McCOMAS WAREHOUSE

ADDITION

DRAINAGE COMMENTS

DRAINAGE PLAN
FOR
McCOMAS WAREHOUSE ADDITION NO.2
2315 4th Street, N.W.
ALBUQUERQUE, NEW MEXICO

GRADING PLAN

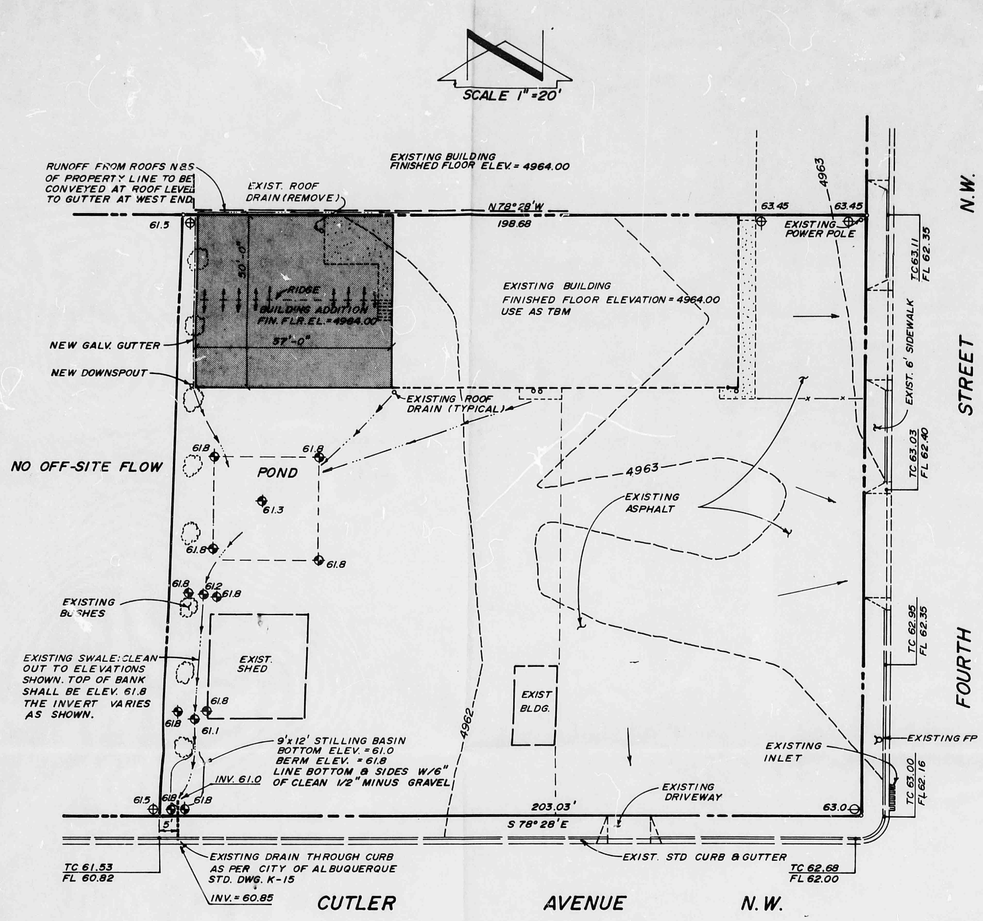
1. PER PRE-DESIGN CONFERENCE, THE FOLLOWING REQUIREMENTS HAVE BEEN ESTABLISHED FOR THE BUILDING ADDITION:

A. THE SURVEY INFORMATION SHOWN ON THE DRAINAGE PLAN FOR THE FIRST ADDITION IS ADEQUATE FOR THIS PLAN.

B. NO ADDITIONAL PONDING IS REQUIRED AND POND CAN BE ELIMINATED IF DESIRED. (A SMALL PORTION OF THE POND IS RETAINED TO REDUCE THE PEAK FLOW SO THAT THE CAPACITY OF THE 4" PIPE THROUGH THE CURB WILL NOT BE EXCEEDED. IF IT BECOMES DESIREABLE TO ELIMINATE THE POND ENTIRELY, THEN THE 4 INCH PIPE SHOULD BE REPLACED BY A SIDEWALK CULVERT. THE FIRM MAP SHOWS THAT 4TH STREET IS IN A FLOOD HAZARD AREA WITH A DEPTH OF 1 FOOT.

C. EROSION CONTROL AT INLET OF 4" PIPE. (A GRAVEL LINED STILLING BASIN HAS BEEN PROVIDED.)

D. SHOW OUTLINE OF PROPOSED BUILDING AND FINISHED FLOOR. (THIS HAS BEEN DONE.)

E. ROOF DRAIN DIRECTION AND LOCATION. (THIS ALSO HAS BEEN DONE. ALL ROOF RUNOFF FROM THE ROOF WILL BE DIRECTED TO THE SOUTH SIDE OF THE BUILDING.
